## METROPOLITAN GOVERNMENT OF NASHVILLE AND DAVIDSON COUNTY

### STAFF RECOMMENDATION 110 Lindsley Park Drive March 15, 2017

**Application:** New construction - Infill  
**District:** Lockeland Springs-East End Neighborhood Conservation Zoning Overlay  
**Council District:** 06  
**Map and Parcel Number:** 08309048000  
**Applicant:** John Root, rootArch  
**Project Lead:** Melissa Sajid, melissa.sajid@nashville.gov

**Description of Project:** Application is to construct a new single-family residence on a vacant lot.

EAST ELEVATION - 110 LINDSLEY PARK

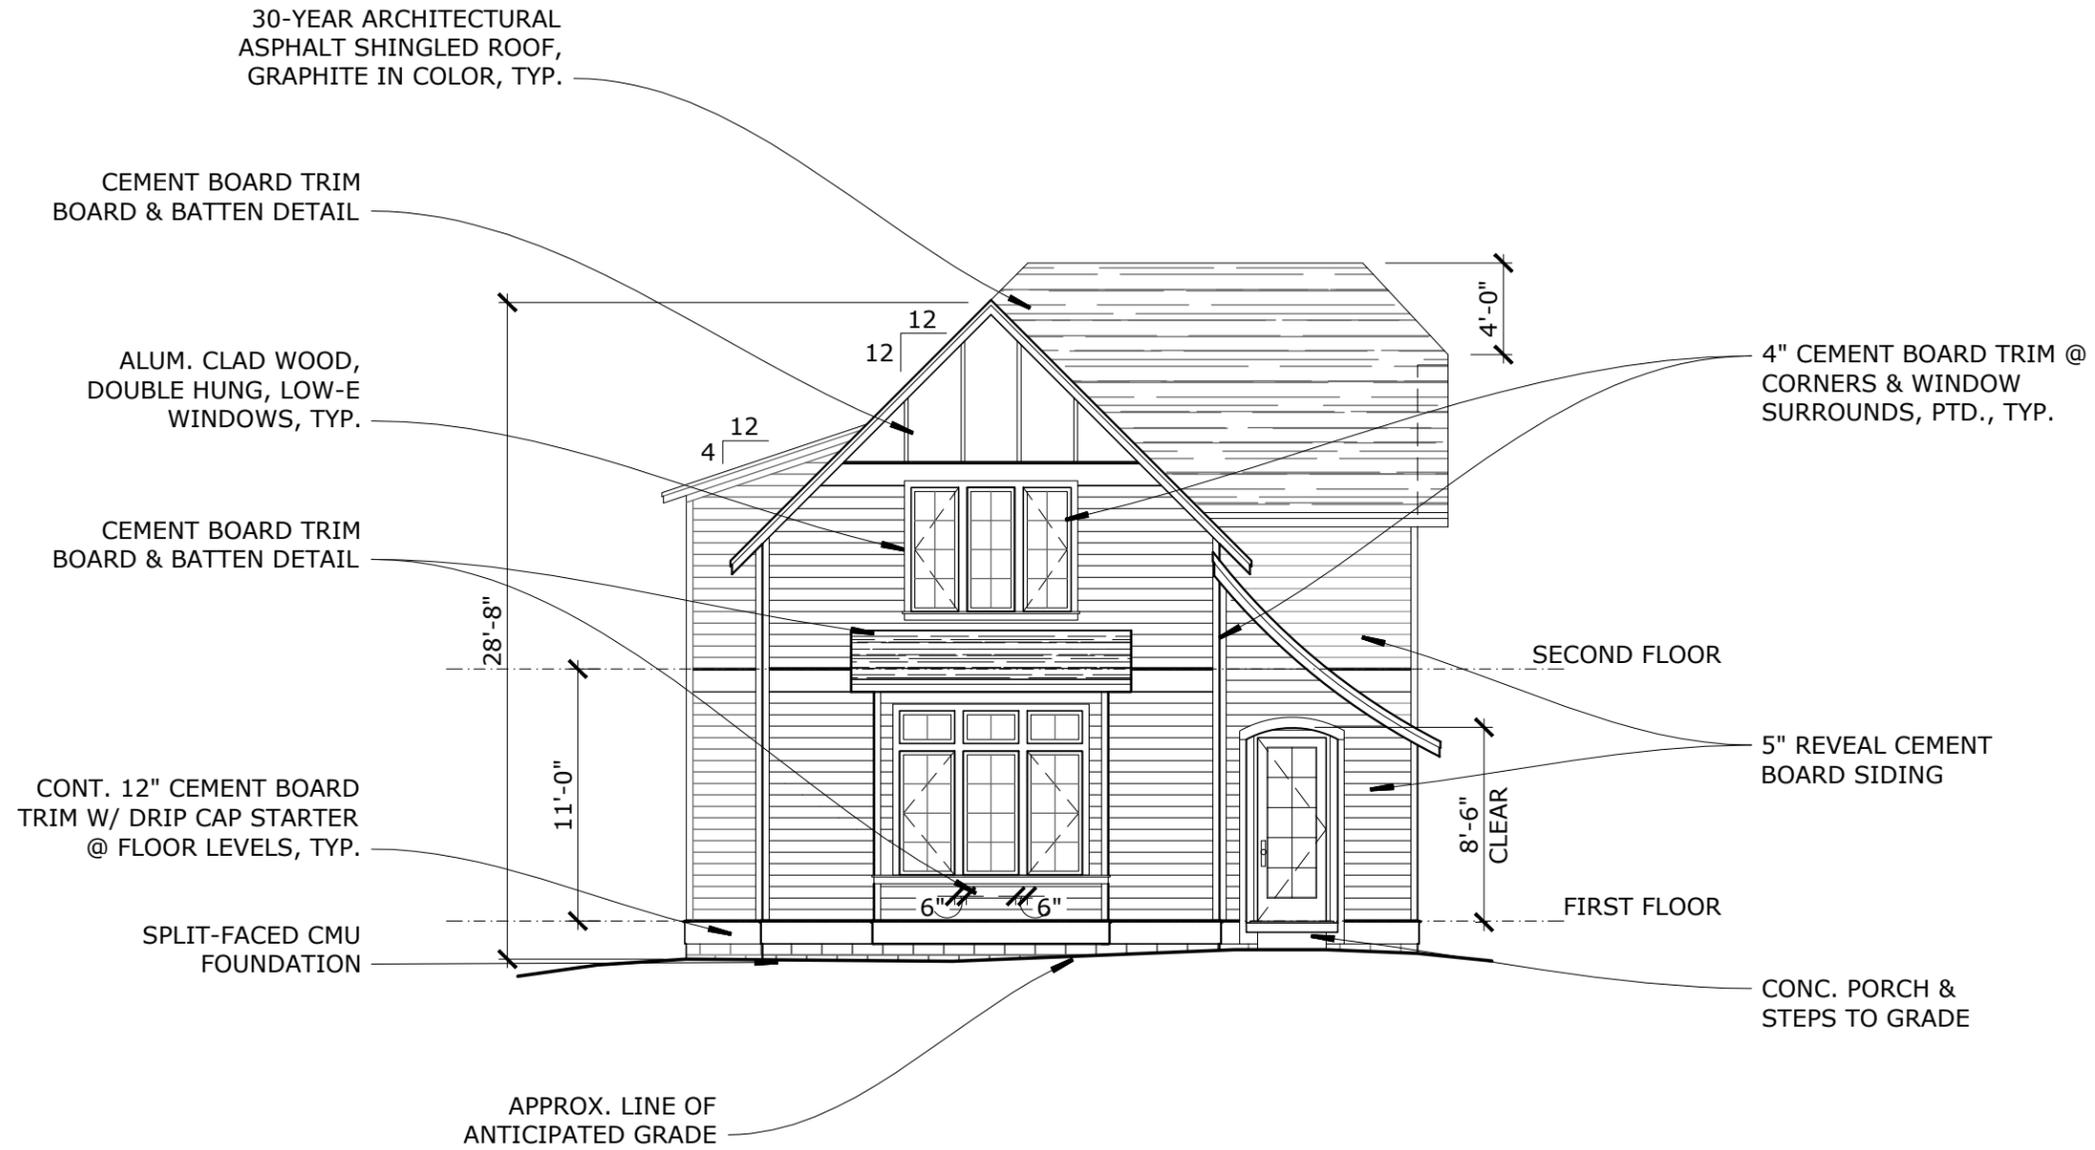
**Height & Scale:** The proposed infill is one and one-half to two-stories stories at the front and three stories at the rear. The primary eaves are approximately twenty-feet (20’) from the front grade. Although the form of the house mimics a one-and-one-half story home, mitigating the overall massing, the tall eaves are more akin to a full two-story home.

The overall height of the building, facing Lindsley Park Drive is approximately thirty feet (30’ 2”) from the front grade. The overall height includes a foundation height of approximately two feet (2’) at the front of the building. At the rear, facing South Fifteenth Street, the house will be approximately forty-one feet (41’) tall.

The scale of the building is two-stories with eave heights of a two-story building whereas all of the historic homes on Lindsley Park Drive have the massing of one and one and one-half story homes. While the Commission did approve a two-story house with an overall height of twenty-seven feet, six inches (27'-6") at 104 Lindsley Park Drive eight years ago in 2009, more recently the Commission has looked more to the immediate historic context with regard to height and scale when evaluating proposed infill. The majority of historic homes on Lindsley Park Drive as well as adjacent blocks of Holly Street and Woodland Street are one and one and one-half (1-1.5) stories. Therefore, staff finds that the predominantly two-story scale that is proposed is inappropriate for infill at this location.

Homes in the immediate historic context range from sixteen feet to twenty-eight feet (16'-28') tall. Given the historic height context, as well as the change in grade on site that allows for three (3) stories at the rear, staff finds that the combination of eave and ridge heights creates a massing that is inappropriate for the context.

Staff finds that while the width of the infill could be appropriate for the context, the proposed massing and overall height are not compatible with the scale of the immediate historic context, which includes one and one-and-one-half (1-1.5) story homes that range from sixteen feet to twenty-eight feet (16'-28') in height.. For these reasons, staff finds that the infill does not meet sections II.B. 1 and 2 for infill.

Staff recommends disapproval based on the fact that the proposed house exceeds the established scale of one to one and a half story historic homes in the immediate area and therefore does not meeting the design guidelines for scale, for the Lockland Springs-East End Neighborhood Conservation Zoning Overlay.

SOUTH ELEVATION - 110 LINDSLEY PARK

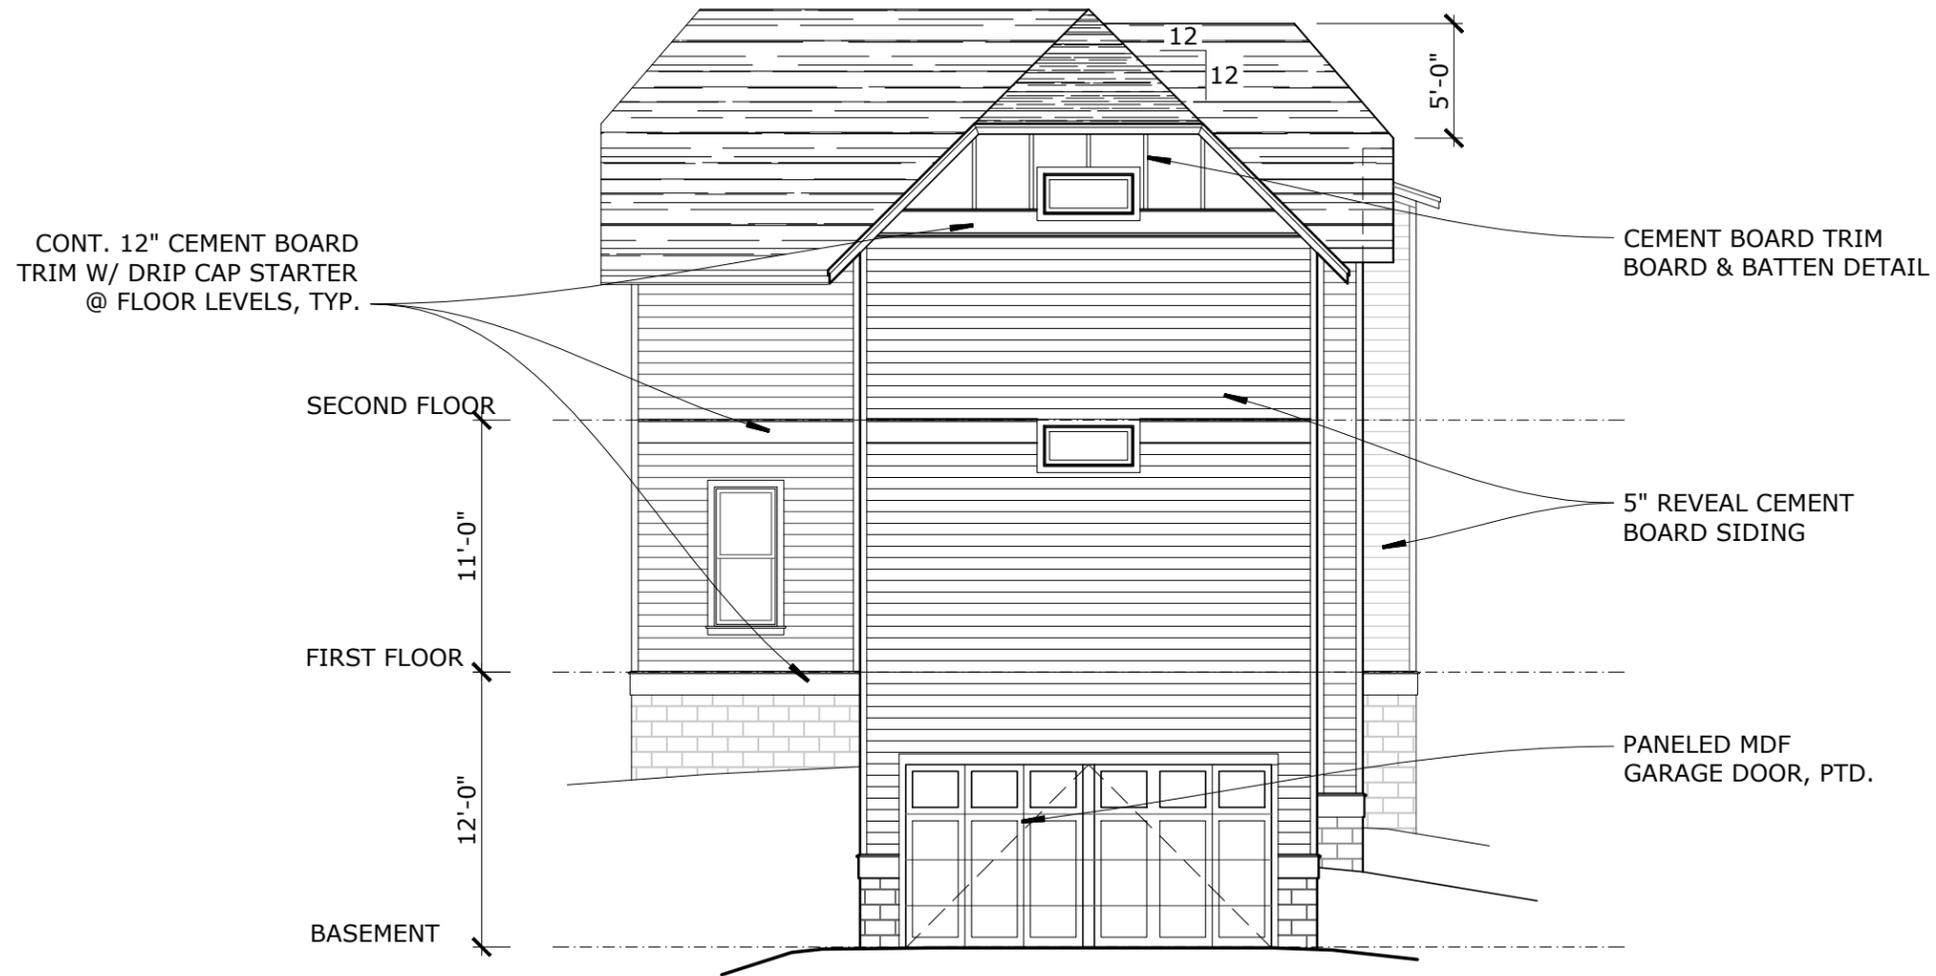
Proportion and Rhythm of Openings: Most of the windows on the proposed infill are generally twice as tall as they are wide, thereby meeting the historic proportions of openings. The plan does include several smaller horizontal windows on the rear and left side façades. Staff, however, finds that these windows could be appropriate given their locations and the change in grade on site as they will not likely be visible from the street. There are no large expanses of wall space without a window or door opening. Staff finds the project's proportion and rhythm of openings to meet Section II.B.1.g.

NORTH ELEVATION - 110 LINDSLEY PARK

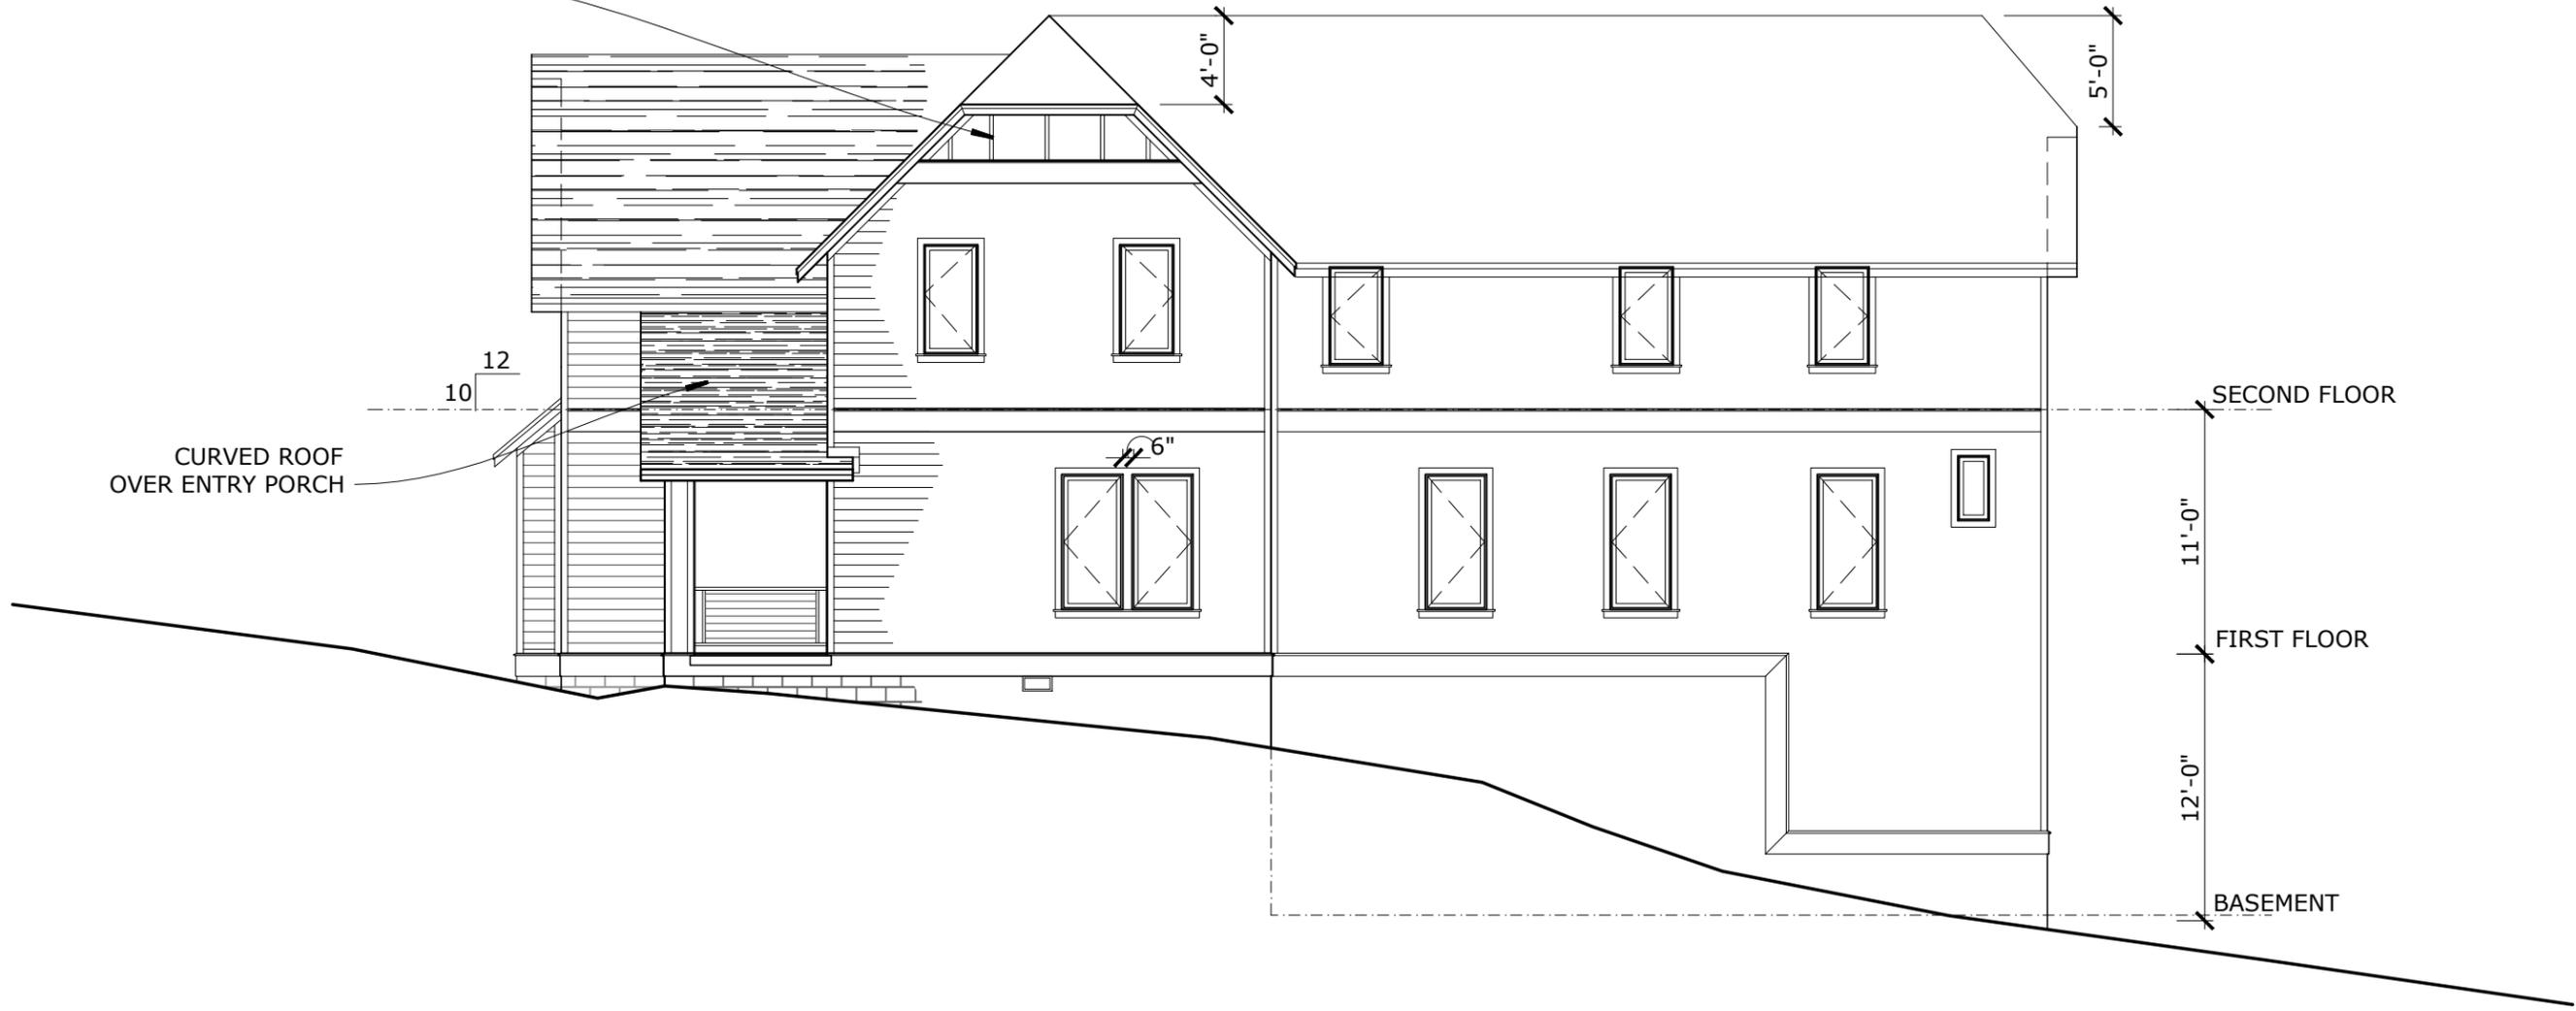
Roof form: The roof will be a clipped cross-gabled with a primary roof pitch of 12:12 and includes a two-story bay on the left side with a pitch of 4:12. Staff finds that the roof form and pitches are compatible with the historic context and meet section II.B.1.e.
